### **Change Order**

PROJECT: (Name and address)
Raymond Community Park

Change Order Number: 04 Date: September 24, 2025

### **ASI#20 - Irrigation Changes**

L5.09

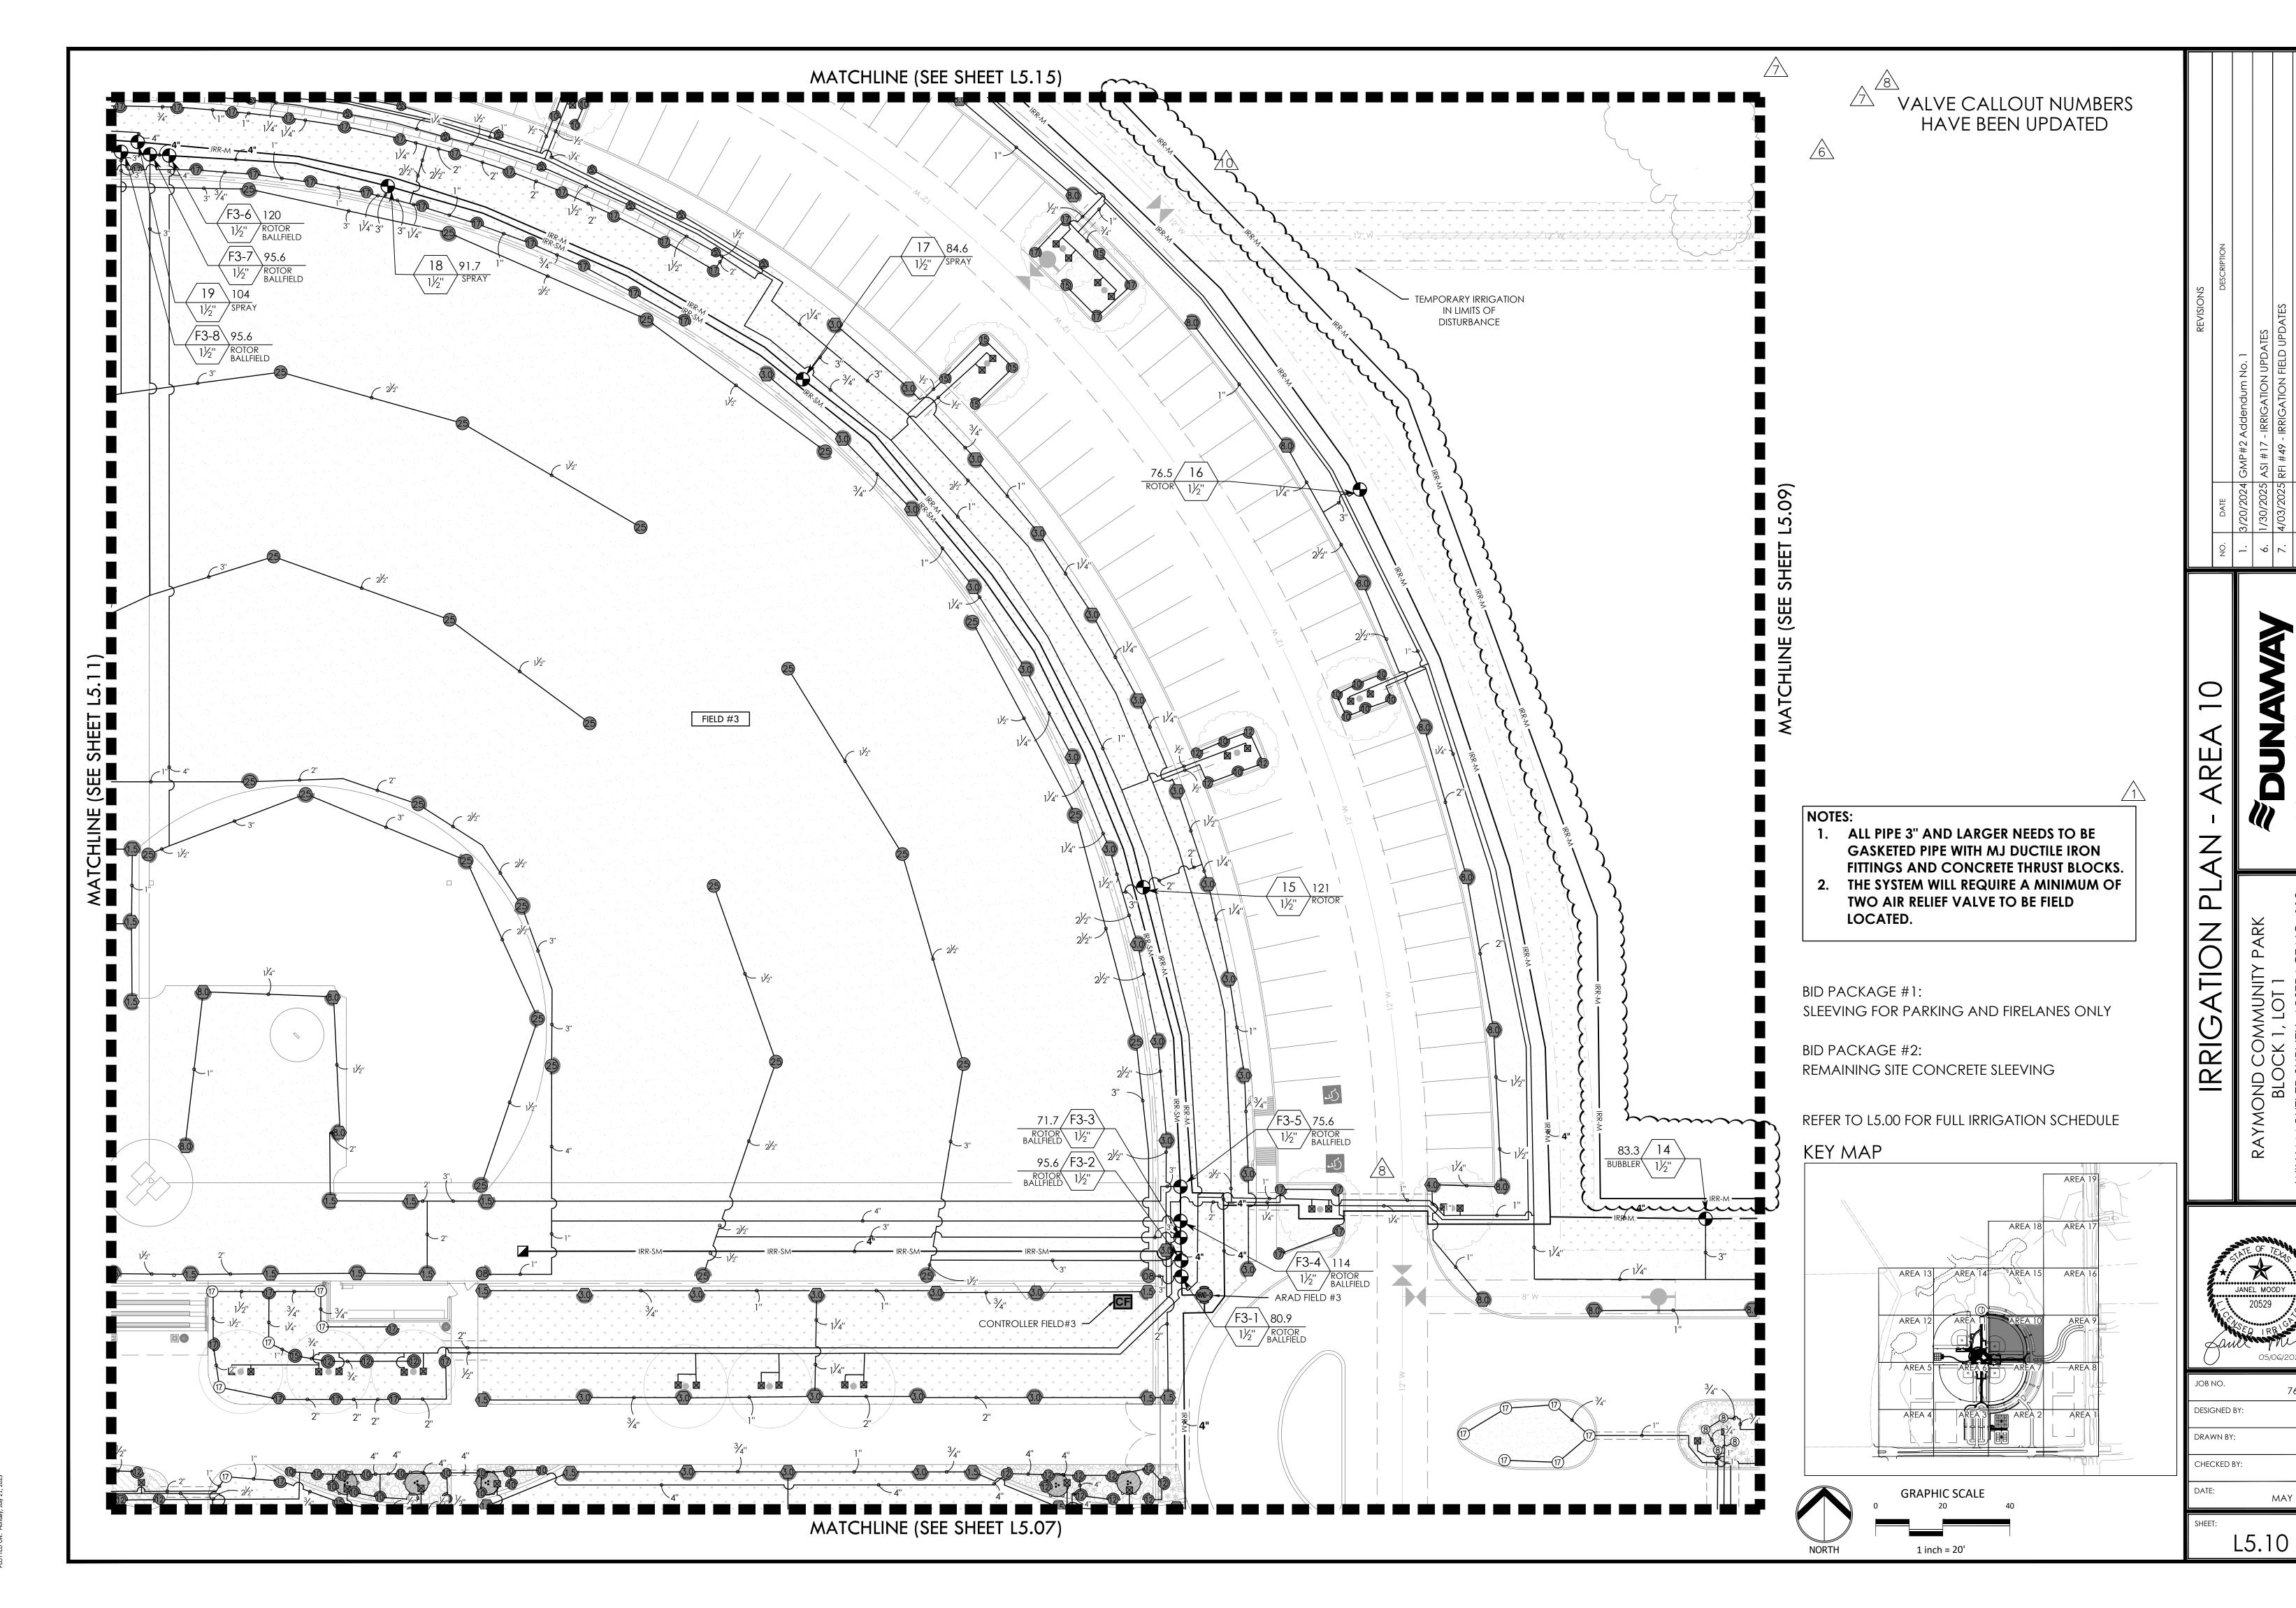
- Sow mainline disconnect in air gap valve box
- 5. L5.08 Irrigation Plan Area 8
  - Add irrigation mainline and sleeve for new north pump location
- 6. L5.09 Irrigation Plan Area 9

- Add irrigation mainline and sleeve for new north pump location
- 7. L5.10 Irrigation Plan Area 10
  - Add irrigation mainline for new north pump location
